AERONAUTICAL CHARTING FORUM
Instrument Procedures Group
October 21-22, 2002
HISTORY RECORD

FAA Control # 02-02-246

Subject: Turn Angle Limits for RNAV Approaches without TAA's

RNAV (GPS) RWY 5L INDIANAPOLIS INTL (IND)

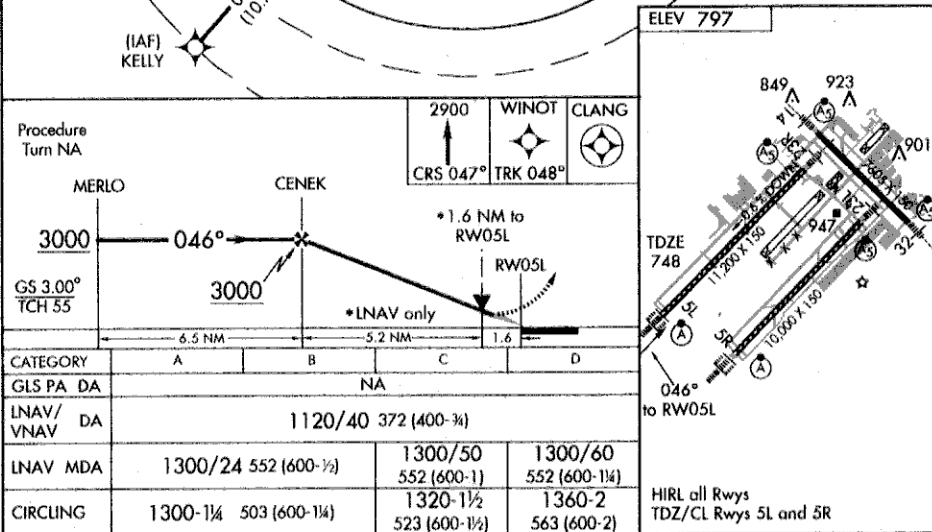
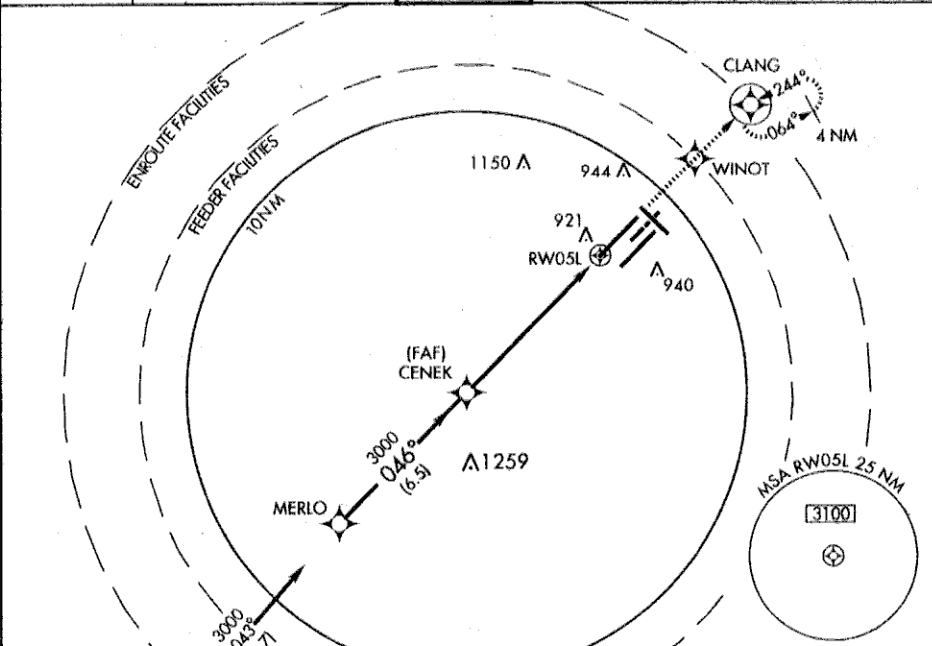
Procedures such as the Indianapolis RNAV (GPS) Rwy 5L and RNAV (GPS) Rwy 32 have no Hold in Lieu Racetrack reversals but instead use IAF waypoints/intersections that are part of the enroute structure.

Establish a system of criteria and charting specifications that will provide explicitly defined and graphically depicted turn angle limits and arrival sectors.

RNAV (GPS) RWY 27R

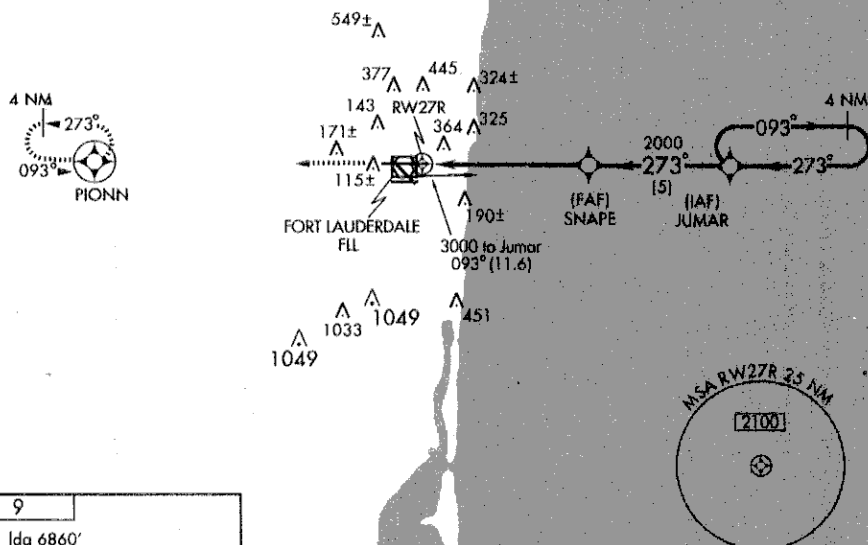
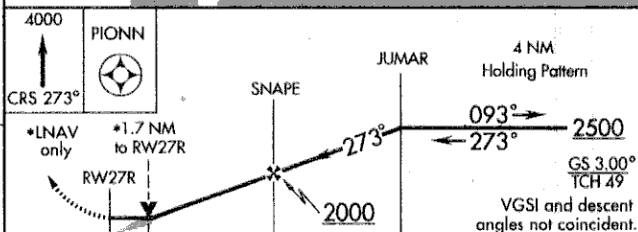
Further, when an approach has a HIL racetrack – and therefore an IF/IAF – it is imperative that pilots and controllers know when it is necessary to begin the approach at the IAF and fly the racetrack reversal. Procedures such as the Fort Lauderdale RNAV (GPS) Rwy 27R have HIL racetracks, but do not specify turn angle limitations on radar monitored clearances direct-to the IF.

FIG 4-8-2
Approach Clearance Example
For RNAV Aircraft

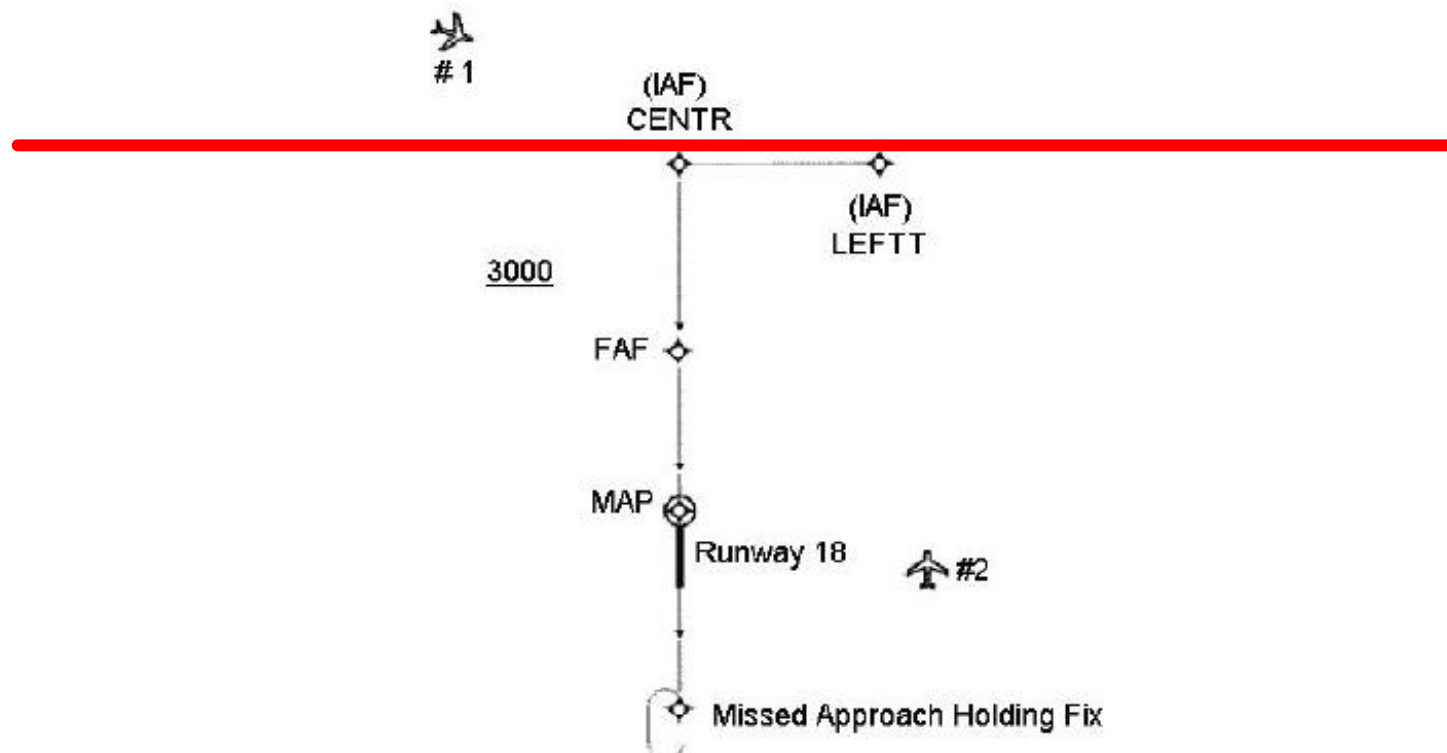
3.	<p>The .65 diagram contained in 7110.326 should change or add another diagram including an example with “CENTR” being an IF. (Steve Bergner (NBAA) I brought a similar recommendation to ACF 03-01 in graphical form suggesting a diagram and example with “CENTR” having a HIL depicted.</p>	Unresolved.

3. Established on a heading or course that will intercept the initial segment at the initial approach fix, or intermediate segment at the intermediate fix when no initial approach fix is published, for a GPS or RNAV instrument approach procedure at an angle not greater than 90 degrees.

Angles greater than 90 degrees may be used when a hold in lieu of procedure turn pattern is depicted at the fix for the instrument approach procedure (see figure 4-8-2).

HPN RNAV (GPS) Rwy 34

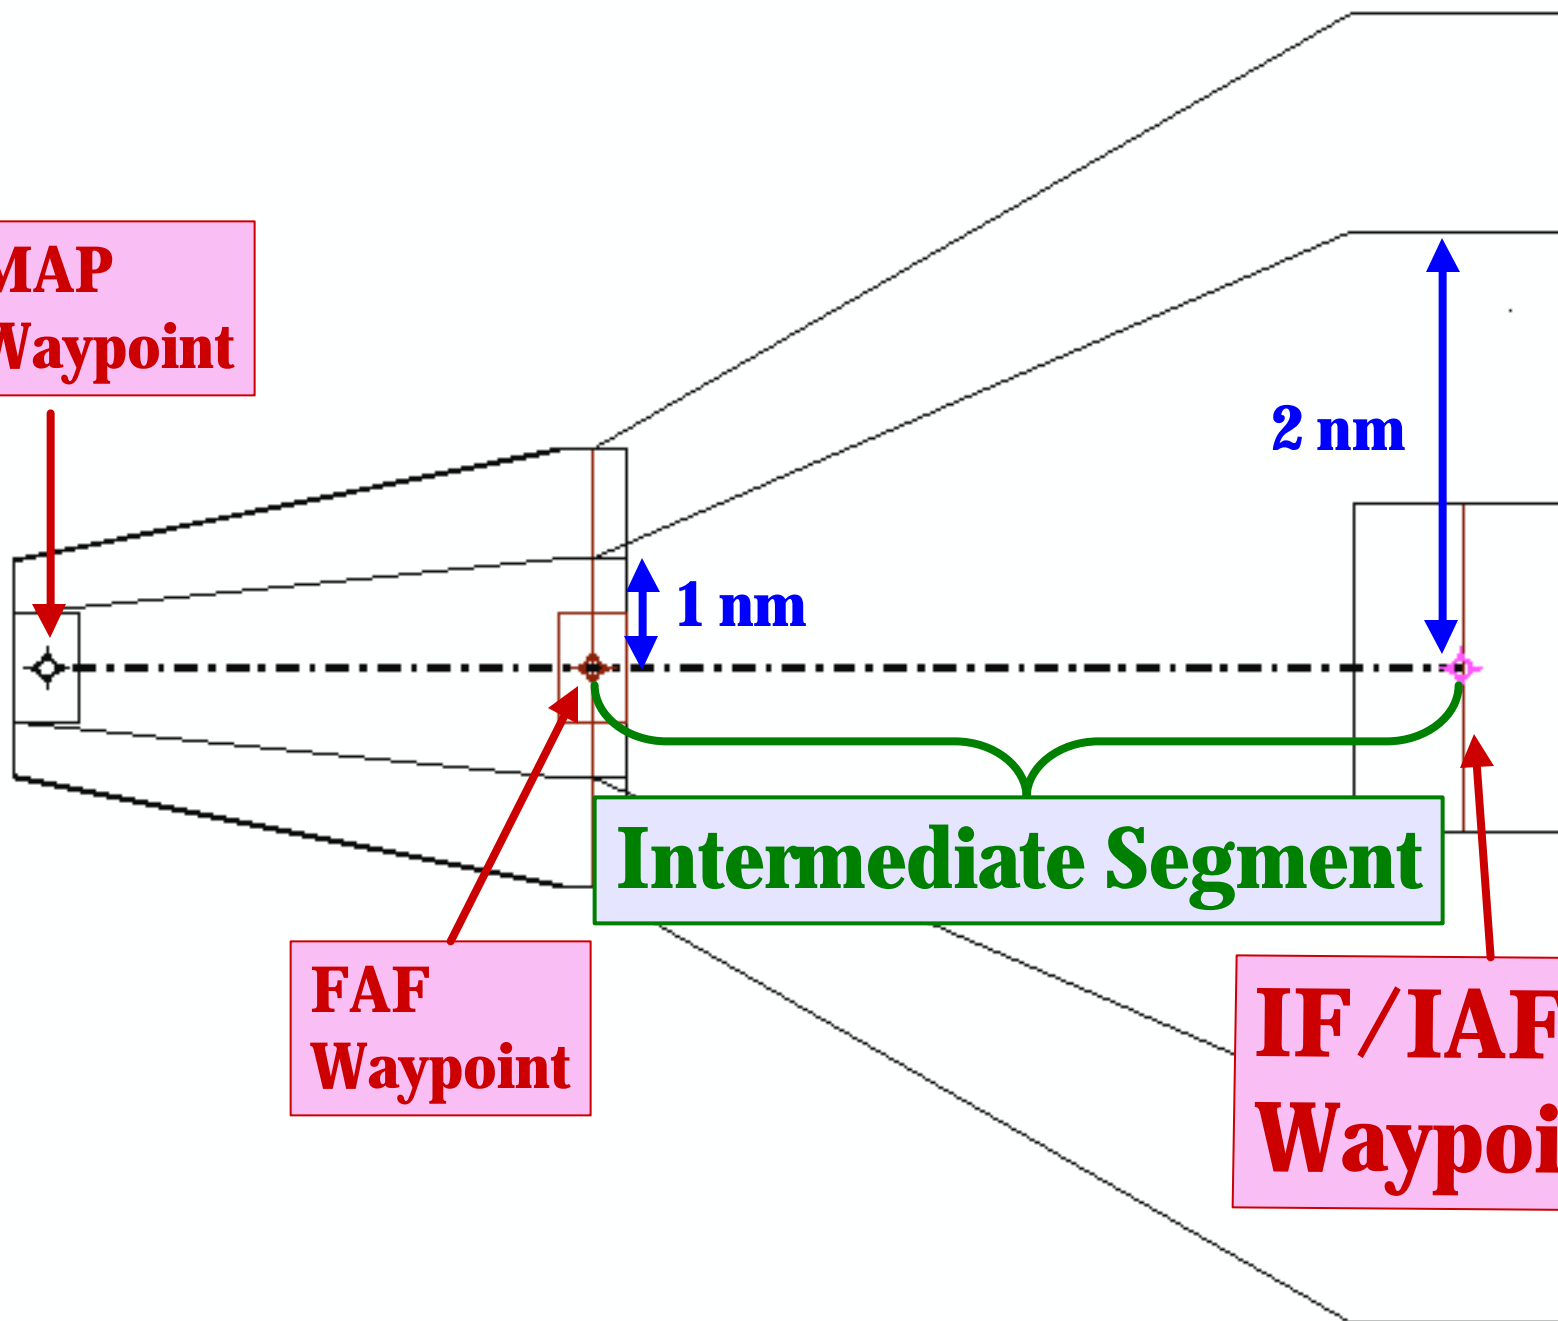
**IF/IAF
Waypoint**

RNAV (GPS) RWY 9L FORT LAUDERDALE-HOLLYWOOD INTL (FLL)

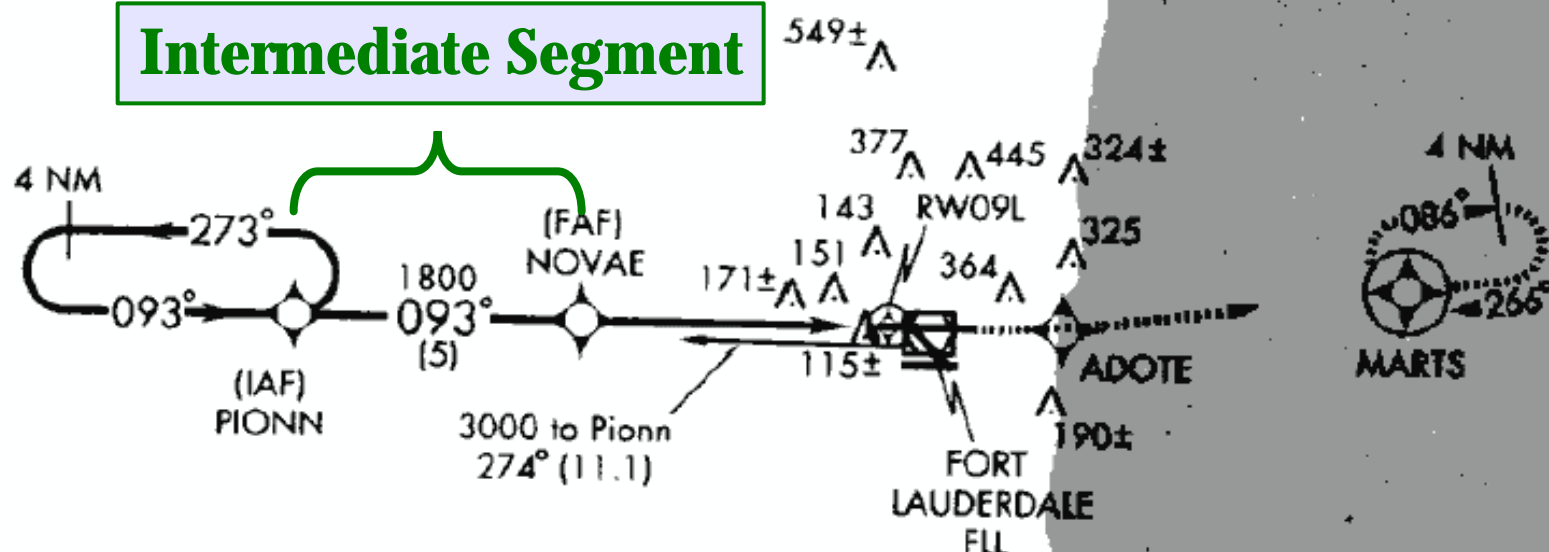
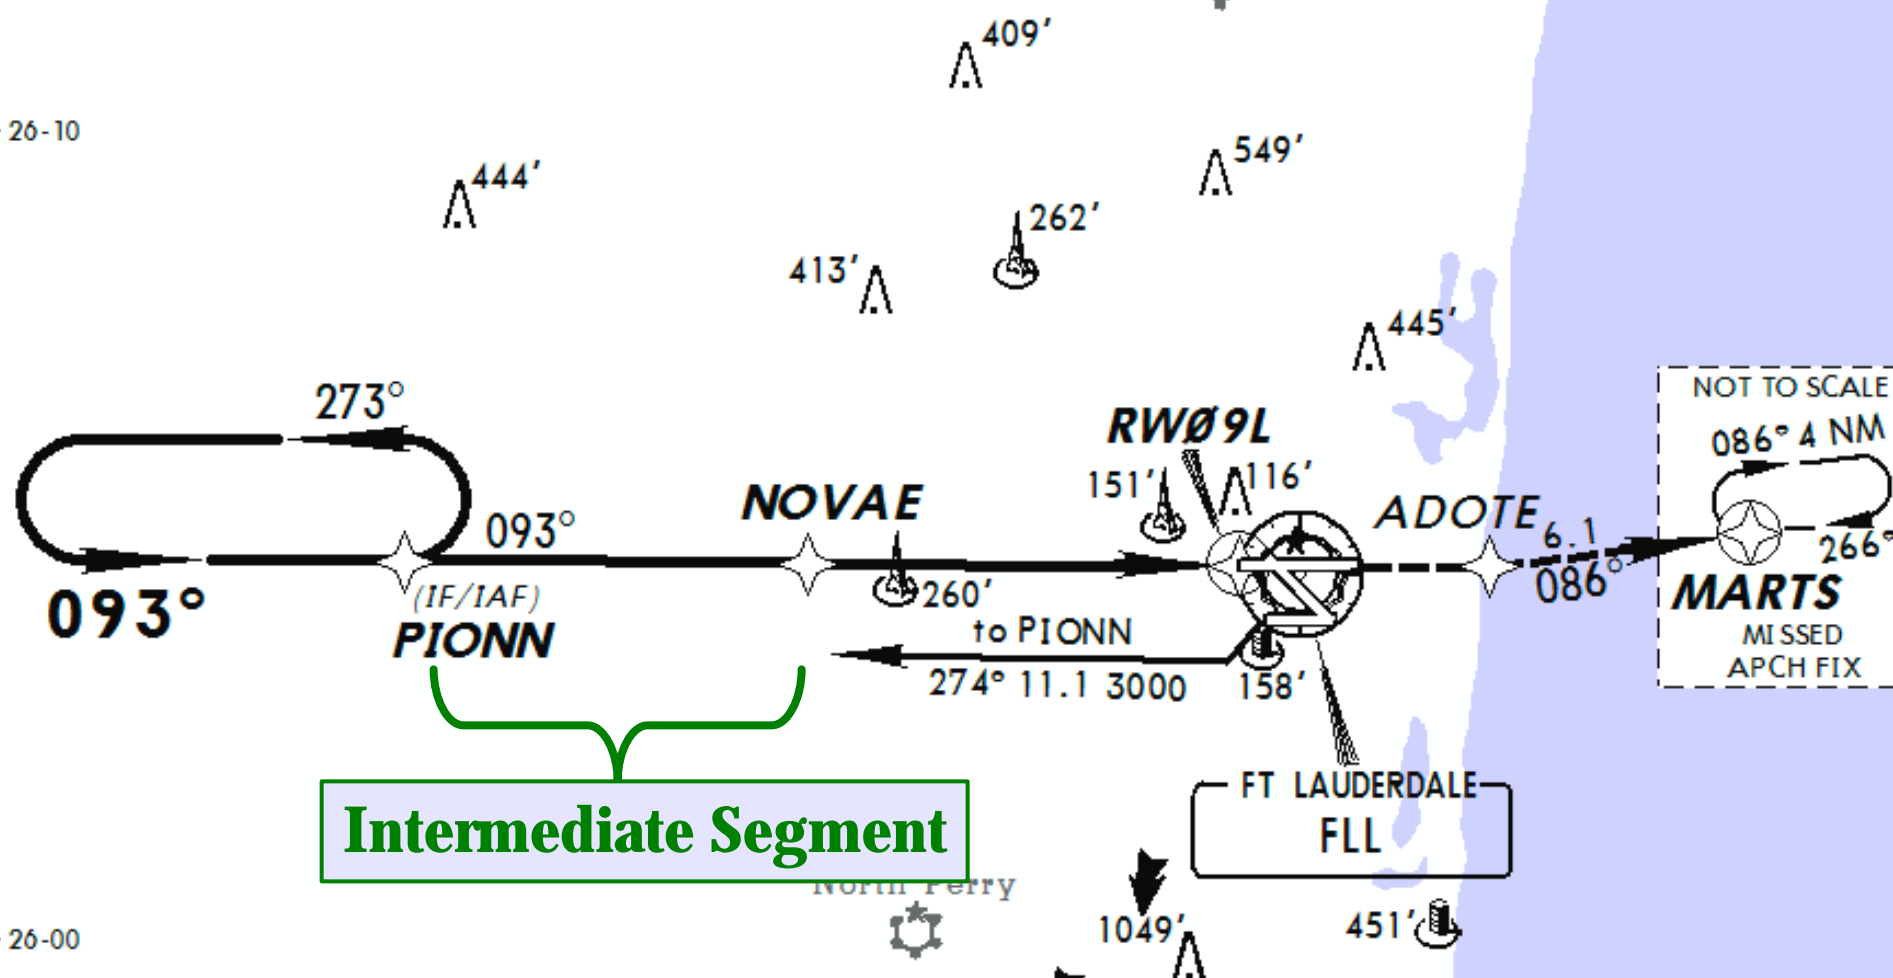
**Is “PIONN” an
Intermediate Fix,
or an IAF?**
